Memorandum

Project: 87-131 Bell Street, Ivanhoe
Our Ref: G25654M-02A
Date: 6th August, 2019

**RE: Response to Council's Memorandum prepared by One Mild Grid (dated 11th July, 2019)
Proposed Mixed Use Development at 87-131 Bell Street, Ivanhoe**

Figure 2: Post-development peak hour traffic volumes

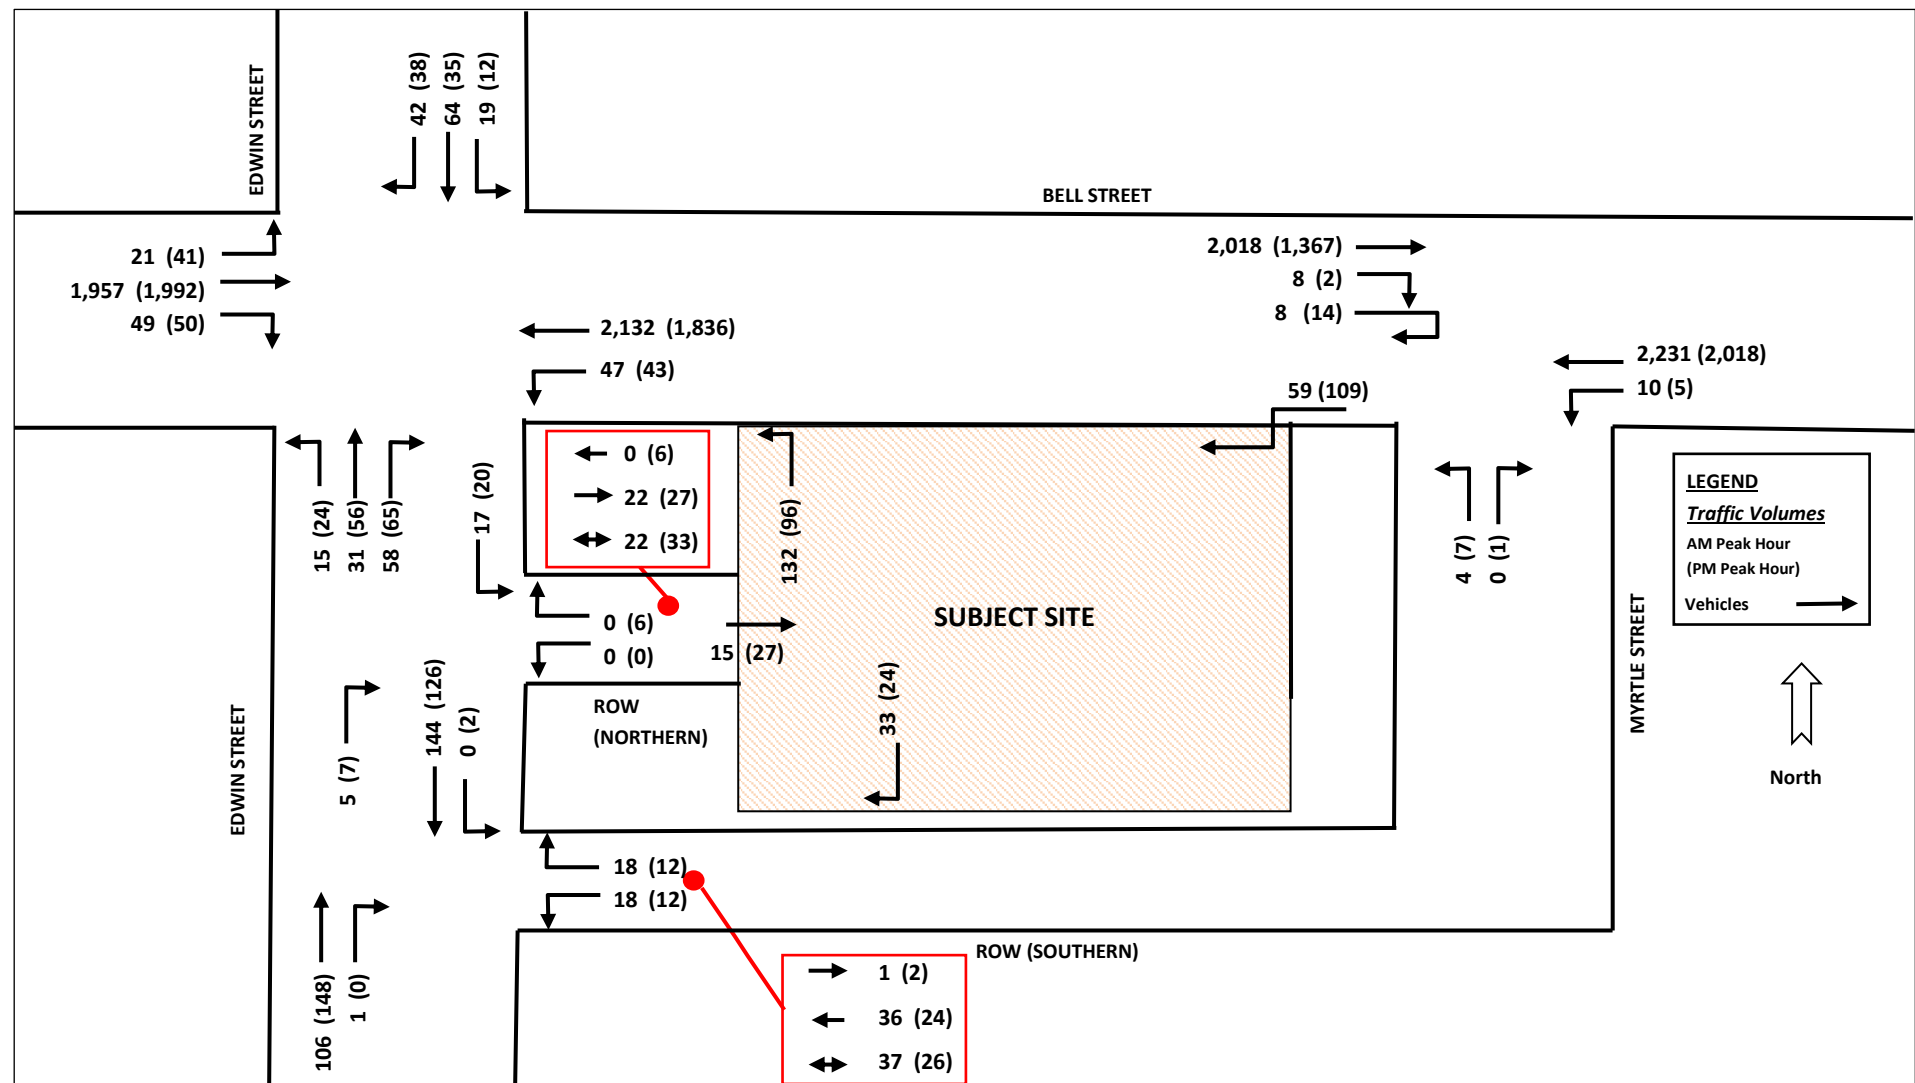
Council outlined within a Memorandum prepared by One Mile Grid (dated 11th July, 2019) that it had concerns regarding traffic volumes within the single-width sections of the northern and southern laneways to and from Edwin Street, as follows:

It should be noted that the Planning Scheme identifies the indicative capacity of the RoW as 300 vehicles per day. It is typically accepted that peak hour volumes represent 10% of the daily traffic volumes for a street, and the Traffix report projects a PM peak hour volume of 35 vehicle movements along the northern RoW. It can therefore be determined that the expected post-development daily traffic volumes of the northern RoW will exceed the indicative capacity. It is recommended that a vehicle conflict analysis be undertaken to understand the probability of two opposing vehicles meeting along the northern RoW and subsequently, how many vehicles would be required to queue as a result of a conflict.

As detailed previously, Council's traffic referral outlined some concerns regarding the capacity of the northern and southern ROW's to accommodate the post-development traffic volumes.

Based on the updated post-development traffic volumes forecast at Section 3.1 and shown at Figure 2, it is expected that in the PM peak hour, there will be a two-way volume of 33 vehicles, comprising 27 'inbound' movements and 6 'outbound' movements. All 27 inbound movements will relate to site generated traffic. This level of traffic is marginally above the threshold to provide for two-way passing opportunities, as directed by AS2890.1-2004. Lower volumes are expected in the AM peak hour.

Based on a review of our conflict data, an average of 1.2 conflicts are expected within the northern ROW across the PM peak hour.

Based on the updated post-development traffic volumes forecast at Section 3.1 and shown at Figure 2, it is expected that in the AM peak hour, there will be a two-way volume of 37 vehicles, comprising 1 'inbound' movement and 36 'outbound' movements. 33 of the 36 outbound movements will relate to site generated traffic. This level of traffic is marginally above the threshold to provide for two-way passing opportunities, as directed by AS2890.1-2004. Lower volumes are expected in the PM peak hour, which will be within this threshold.

Based on a review of our conflict data, an average of 1.6 conflicts are expected within the southern ROW across the PM peak hour.
